Staff Report

Re: PLNHLC2020-00125, Major Alteration to 761 N Wall St to replace a street-facing addition, and PLNHLC2020-00127, Special Exception to increase allowable lot coverage to forty four percent (44%) at 761 N Wall St.

MAJOR ALTERATION – REPLACEMENT OF ADDITION IN LOCAL HISTORIC DISTRICT

PROPERTY ADDRESS: 761 N Wall Street

Figure 1: View of addition from Wall Street; looking west-southwest

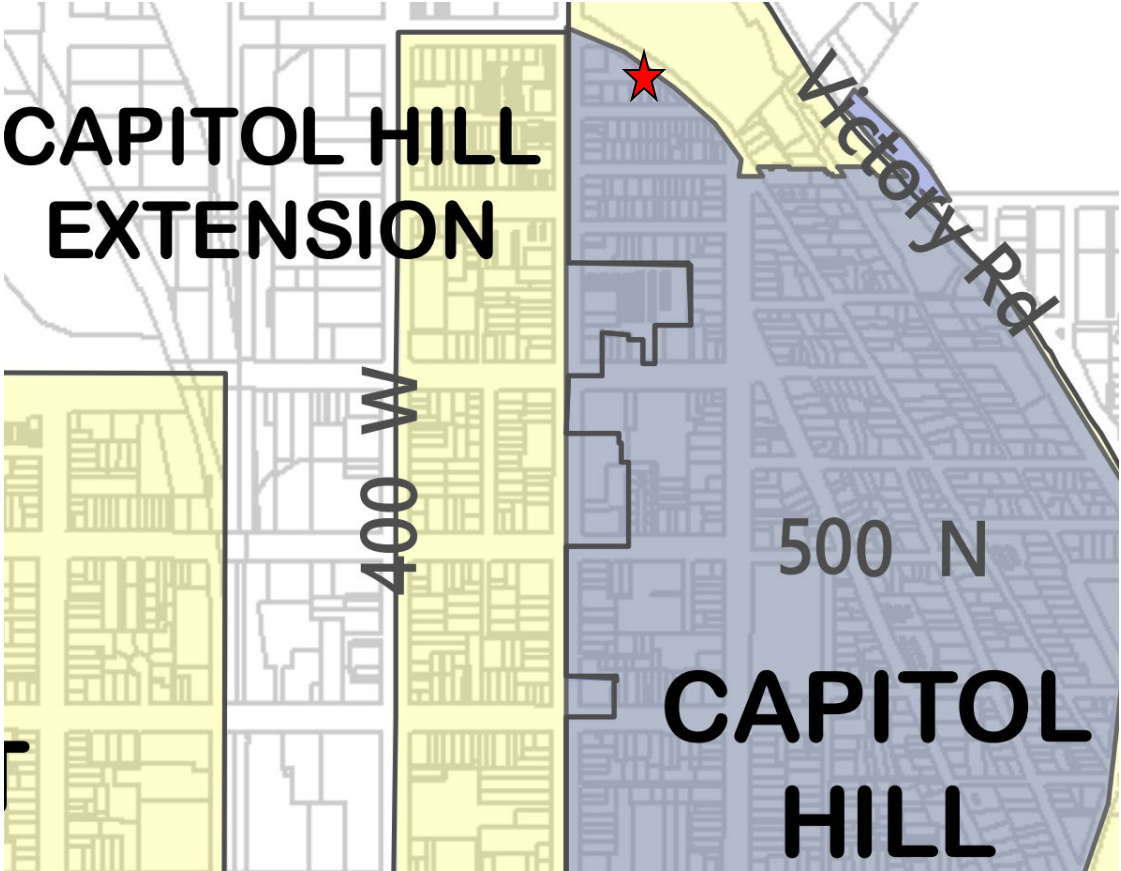
good condition. The existing addition features a shed-type roof which is deteriorating and causing water damage to other areas of the structure. Although Sanborn Fire Insurance maps indicate the property has had an addition in this same location for a while, the current addition does not appear to be historic. It ties into the eastern side of the house but does not have any direct access into the rest of the home; instead it contains a stairwell into the basement. In Staff's conclusion, the removal and replacement of the existing addition will not diminish the character of the existing home and will allow for better roof drainage and longevity of the historic home.

The design will be fully visible from the public way. The addition will primarily occupy the footprint of the existing addition, however, it will also extend to the north and to the east to accommodate the new front entry porch and the author's nook. The entry vestibule will sit proud of the original home's façade though not the front porch, which is a predominate characteristic of the home when viewed from the north on Wall Street. The Applicant has proposed a gable roofline to match the unique roof of the main home; hipped on the east and gabled on the west. The Residential Design Guidelines heavily discourage changing the shape of the historic roof and the replacement of historic materials with non-historic materials. In an effort to satisfy this guideline the Applicant will preserve the unique roof of the home and will lay asphalt shingles over the roof of the addition to match.

Figure 3: 1911 Sanborn Fire Insurance Map

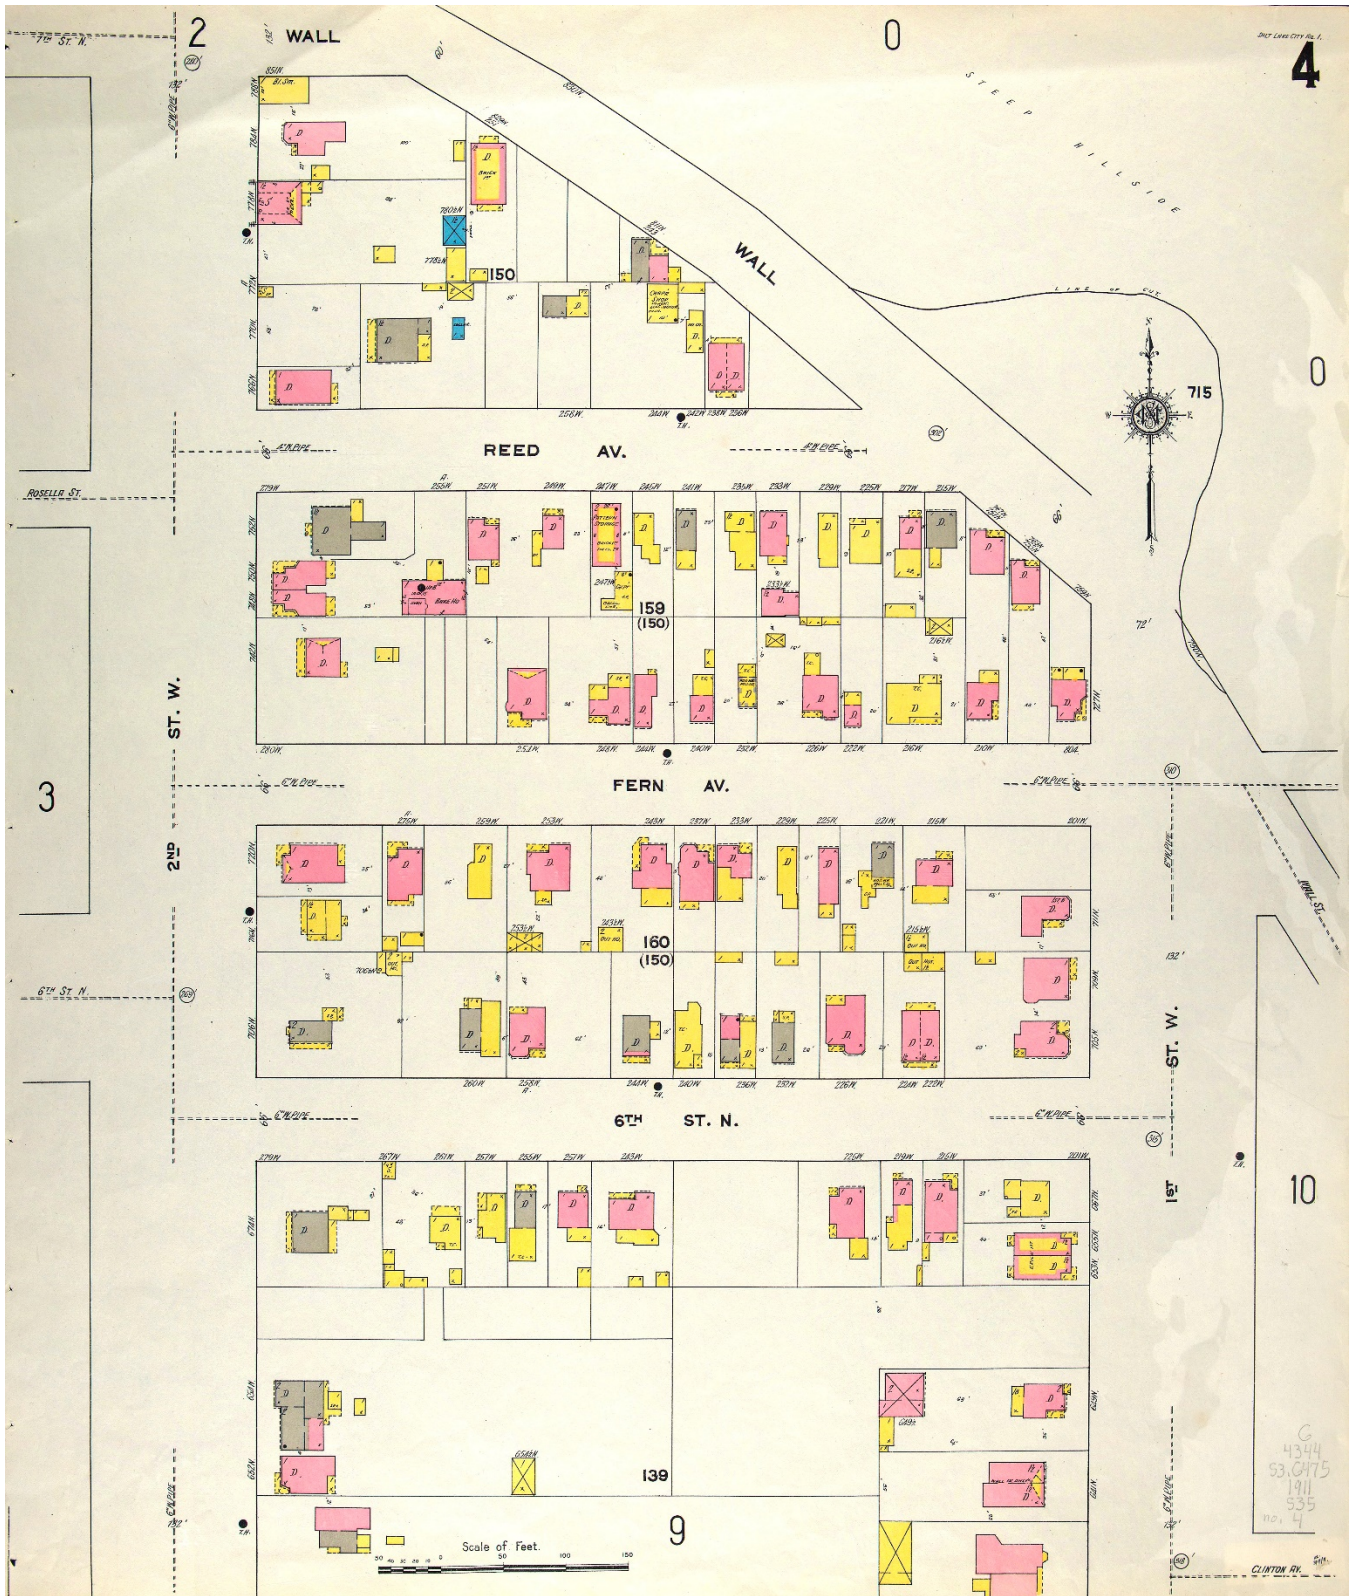
<p>Alterations or additions that have acquired historic significance in their own right shall be retained and preserved.</p>	<p>Complies</p>	<p>Sanborn Fire Insurance Maps from 1911 and 1950 indicate the presence of an addition in the same location on this property. It is unclear when the addition was first constructed or how many times it has been altered before now, however all photos on file with the City show the addition in its current configuration (see Attachment E, photos). Although the addition may be older than 50 years it does not contribute to the form of the building and it is deteriorated. The City has building permit records of minor non-structural upgrades in 2017 but these did not affect the addition.</p>
<p>Distinctive features, finishes and construction techniques or examples of craftsmanship that characterize a historic property shall be preserved.</p>	<p>Complies</p>	<p>The unique roofline of the original building (western end gabled, eastern end hipped) will be preserved; the proposed addition will have a gabled roof which will complement the roofline of the primary sections of the residence. No alterations will be made to the exterior of the first two wings of the home.</p>
